Access Compliance Report

Public Rights-of-Way

(Curb Ramps)

Intersection ID: 50848	Main Street: REA_RD	Cross Street: BELCHER_LN	Location: SE
ADA ID: C9FF5B7572B7	Ramp Type: Perp	Initial Pass/Fail: Fail	Overall Compliance: No
Severity Score: 21.25			
Codes/Mitigation Info/Possible Solution		Field Measurements/Component Compliance

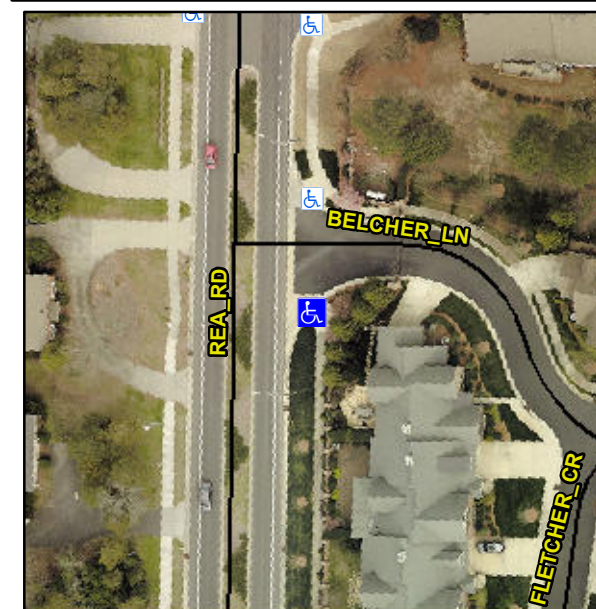
Not Found, R304.5.1, R304.5.3

Compliance	Description	Data	Compliance	Description	Data
N/A	Ramp Length (in)	73.0	Yes	Ramp Slope (%)	5.7
No	Ramp Width (in)	46.5	No	Ramp XSlope (%)	5.4
N/A	Flare Type LT	N/A	N/A	Flare Type RT	N/A
N/A	Flare Slope LT (%)	N/A	N/A	Flare Slope RT (%)	N/A
N/A	Flare Traversable LT?	N/A	N/A	Flare Traversable RT?	N/A
N/A	Landing Length (in)	N/A	N/A	DWS Provided?	N/A
N/A	Landing Width (in)	N/A	N/A	DWS Contrast?	N/A
N/A	Landing Slope (%)	N/A	N/A	DWS Length (in)	N/A
N/A	Landing X Slope (%)	N/A	N/A	DWS Full Width?	N/A
N/A	Landing Curb? (Y/N)	N/A	N/A	DWS Offset (in)	N/A
N/A	Shared Landing?	N/A			
N/A	Gutter Ponding?	N/A	N/A	Gutter Slope (%)	N/A
N/A	Gutter Lip Ht (in)	N/A	N/A	Gutter X Slope (%)	N/A
N/A	Painted X Walk1?	No	N/A	Painted X Walk2?	N/A
	X Walk 1 Direction	To N		X Walk 2 Direction	N/A
N/A	X Walk 1 Width (in)	N/A	N/A	X Walk 2 Width (in)	N/A
	X Walk 1 Slope (%)	2.8		X Walk 2 Slope (%)	N/A
	X Walk 1 X Slope (%)	5.5		X Walk 2 X Slope (%)	N/A

Remove & Replace Entire Ramp.
